DART SERVICE INSTRUCTION

TO AMEND INSTALLATION INSTRUCTIONS D350-591 REV. G AND INSTRUCTIONS FOR CONTINUED AIRWORTHINESS ICA-D350-591 REV. 3

REF TCCA STC: SH92-6
REF FAA STC: SH967NE

TO PROVIDE AN OPTIONAL CUSHION KIT TO BE INSTALLED ON THE D350-591-111A/-113/-115/-117A/-119 *Heli-Access-Step™* (THE D2856-400-720 ABRASION STRIP IS REPLACED WITH THE D3595-200-300 CUSHION).

FIGURE 32-9: Crosstube Attachment
REF ICA-D350-591

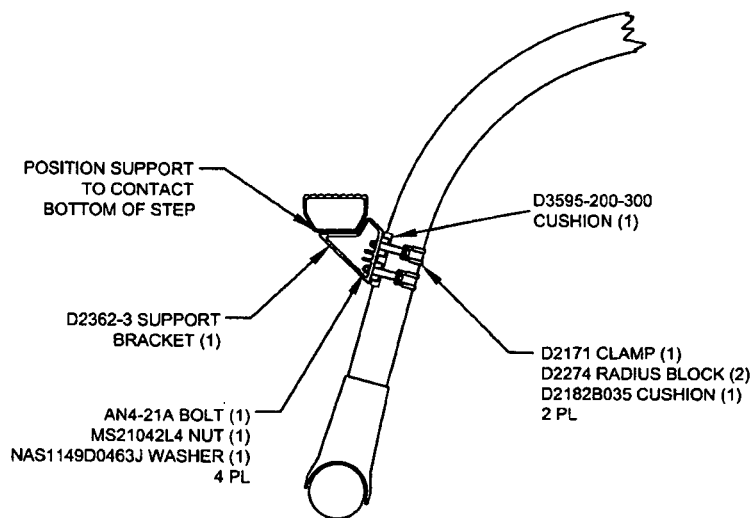
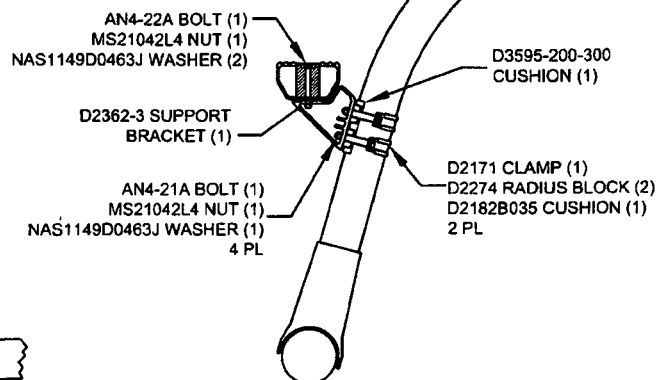
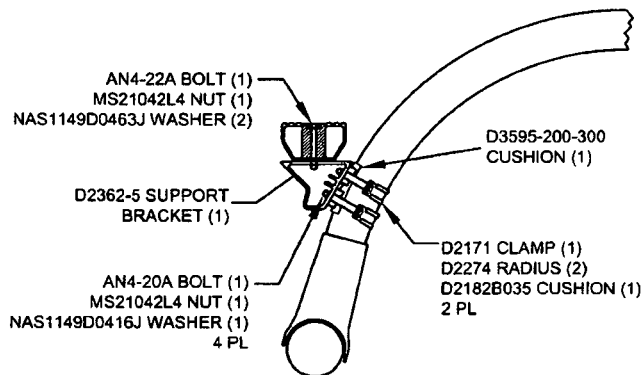
1. REMOVE THE STEP PER ICA-D350-591 SECTION 32.2
2. REMOVE THE D2856-400-720 ABRASION STRIP PER ICA-D350-591 SECTION 32.4
3. POSITION THE D3595-200-300 CUSHION AS INDICATED ON SHEET 3 OR 4 (AS APPLICABLE) OF THIS SERVICE INSTRUCTION.
4. REINSTALL THE STEP PER ICA-D350-591 SECTION 32.1 AS APPLICABLE USING THE NEW HARDWARE PROVIDED AS SHOWN ON SHEET 3 OR 4 (AS APPLICABLE) OF THIS SERVICE INSTRUCTION.
